Change Notification Number: 1227

Change Title: Product range update

Affected Products:

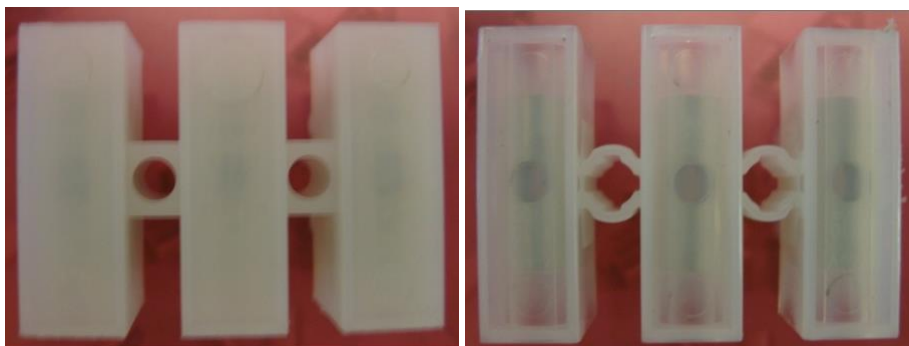
Due to a tooling upgrade the above mentioned products will feature:

1. Guided wire entries - moulding fits the shape of the metal inserts preventing wires from straying outside the inserts.

2. Flexible fixing holes – gives greater adaptability to different fixing methods

3. A higher purity polyamide will be used. This has a more transparent look and will result in no sharp edges
4. Minor dimensional changes:

5. CTSN634 only – maximum temperature is to be reduced from 180°C to 160°C
